Document Change Notice (DCN) Title:

Document No. Doc-Rev		New Rev
D0902744-v2	ISI Coil Driver Change Notice	V3

Here is the schematic representation of the change in question:

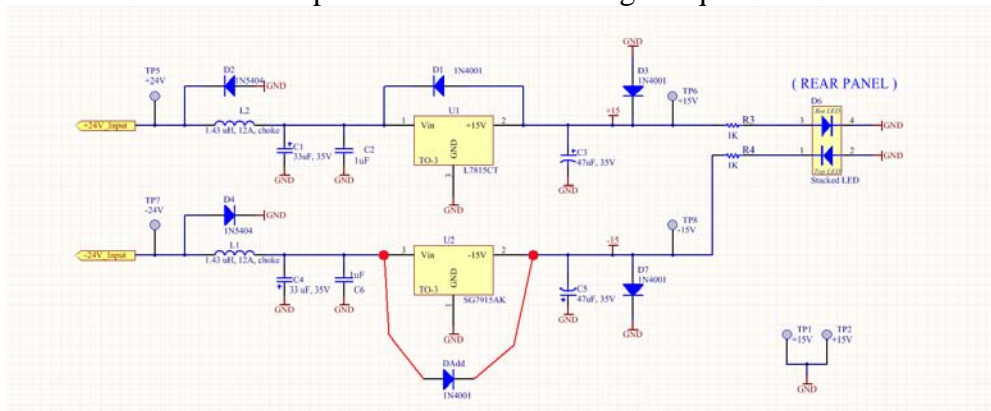
Rev v2 has been changed to v3 by adding a diode “DAdd” between pins 3 and 2 of the negative Voltage Regulator, U2. The diode Anode should be connected to pin 3, and its cathode should be connected to pin2 as in the accompanying pictures.

REASON FOR CHANGE: To protect the negative Voltage Regulator in the Coil Driver Chassis from input power fluctuations.

Location of U2:

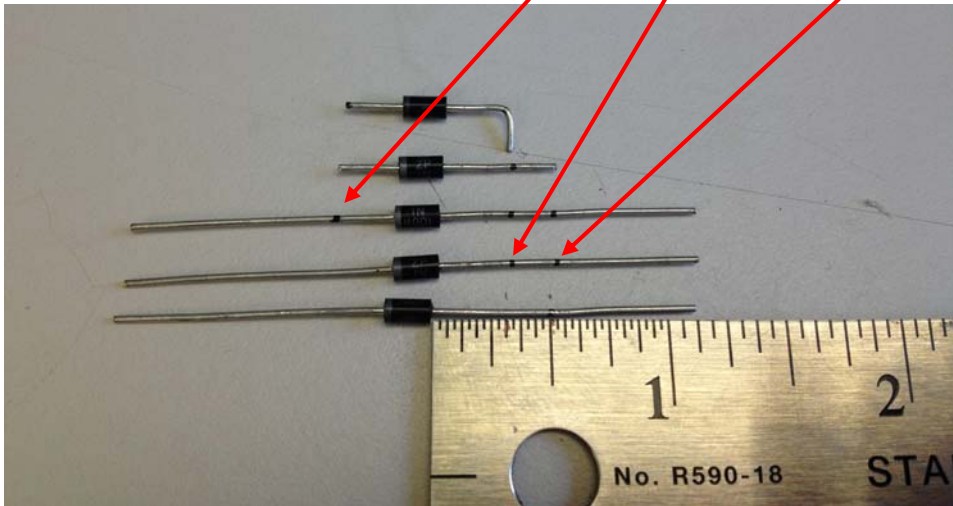
In order to make the change, first the rear panel must be removed from the Coil Driver chassis. This should only involve the removal of the 16 peripheral screws on the back panel. With all of the internal cabling in place, it should be possible to gently pull out the panel, and board, and get to the underside of the board. This is also a good time to verify that the Binary I/O DCN, E1100821 has been performed. If not, please make that change at the same time as this one, and note it on the E-Traveler.

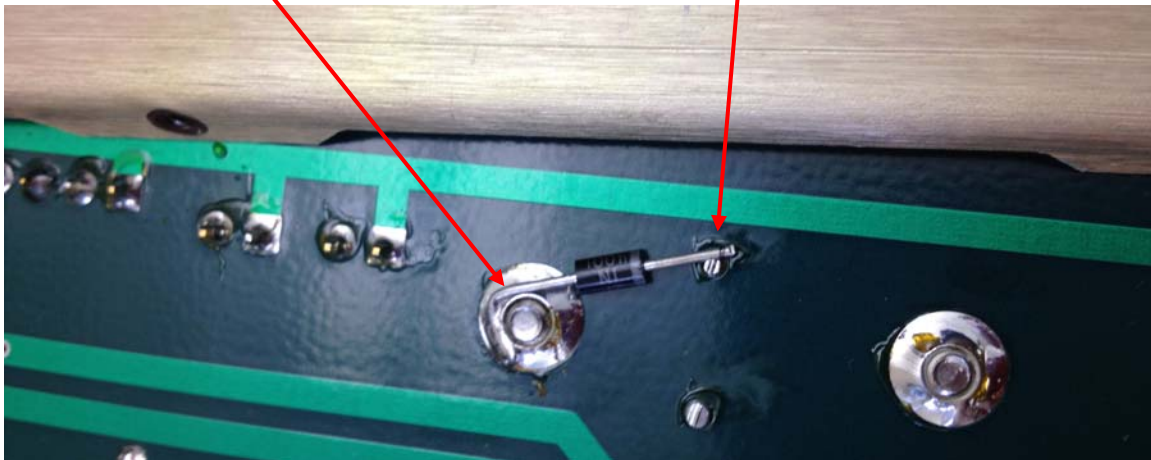
On the Anode of the diode, make two marks, one at $\frac{5}{16}$ " , and one at $\frac{1}{2}$ " . On the Cathode side of the diode, make a mark at $\frac{1}{4}$ " .

Cut the leads at the $\frac{1}{4}$ " mark, and the $\frac{1}{2}$ " mark, as in the second diode from the top, above. Bend the Anode lead 90° at the $\frac{1}{2}$ " mark as seen in the top diode.

Bend the pins down to a flat surface so that the bent arm of the Anode, and the tip of the Cathode touch the surface. This will make a better solder joint in the next step:

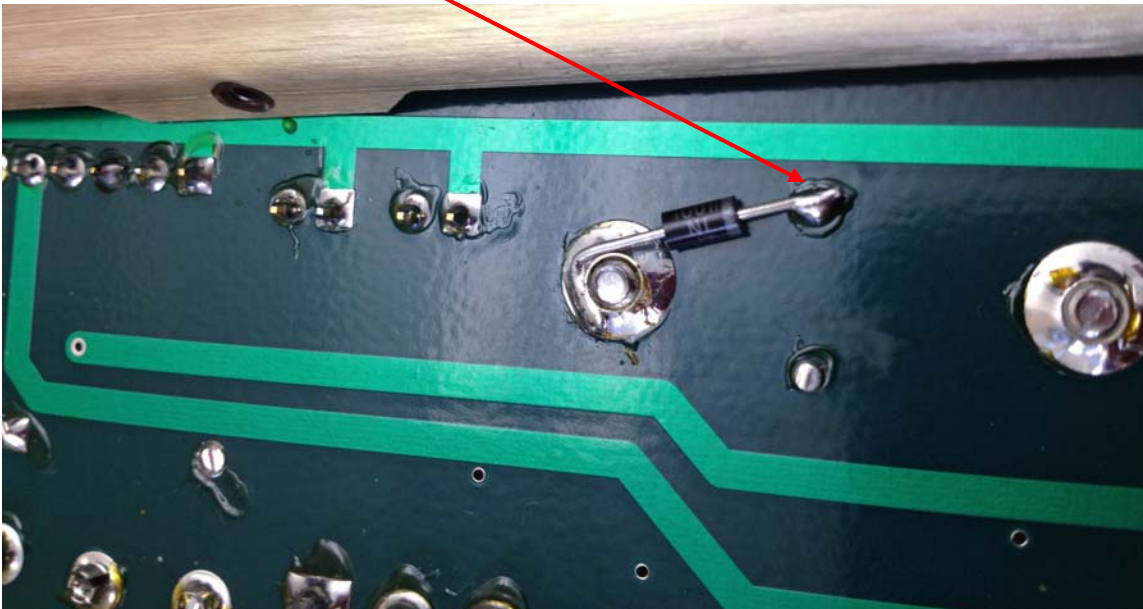
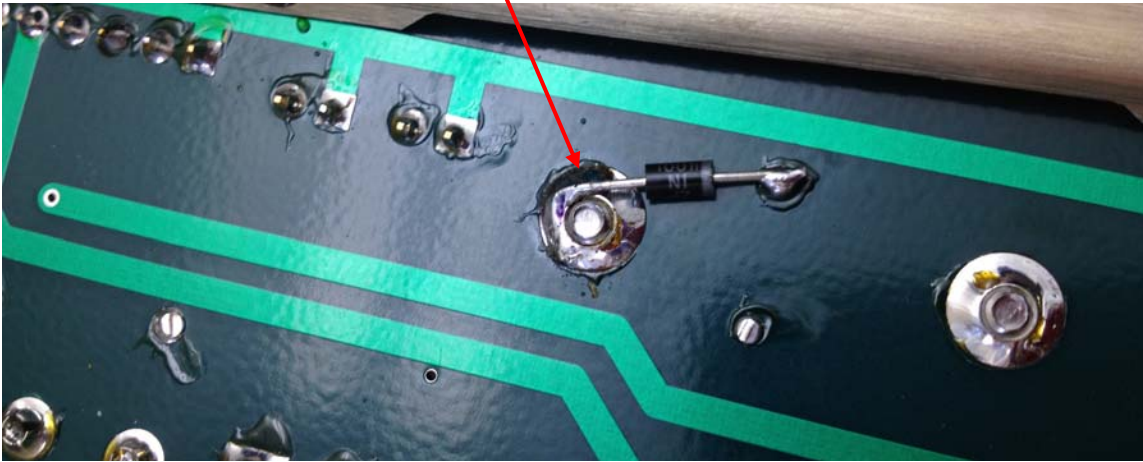
To get good alignment, lightly solder (tack) the bent Anode lead to the large screw-threaded pad (Pin2) of U2, aligning the Cathode with Pin3 of U2.

Now, securely solder the Cathode:

And finally, securely re-solder the Anode, to make a good mechanical joint.

Figure 9 – Fixed Output Regulator

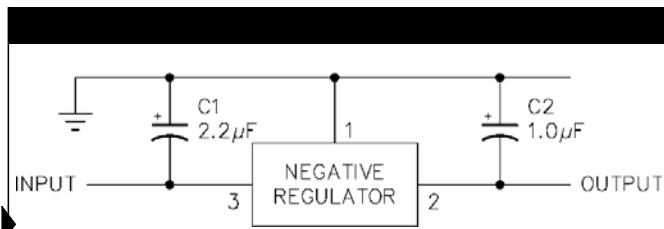
Putting this diode in place is a relatively common method of protection in case the supply voltage goes lower than the output voltage. Although the thought seems to be cut off mid-sentence, the sentiment is there on the Microsemi datasheet:

Note: 1. C1 is required only if regulator is separated from rectifier filter.
 2. Both C1 and C2 should be low E.S.R. types such as solid tantalum. If aluminum electrolytic capacitors are used, at least 10 times values shown should be selected.
 3. If large output capacities are used, the regulators must be protected from momentary input shorts. A high current diode.

I'm sure that the sentence "A high current diode" should have ended with "should be placed from Pin 3 to Pin2", as we have done here.
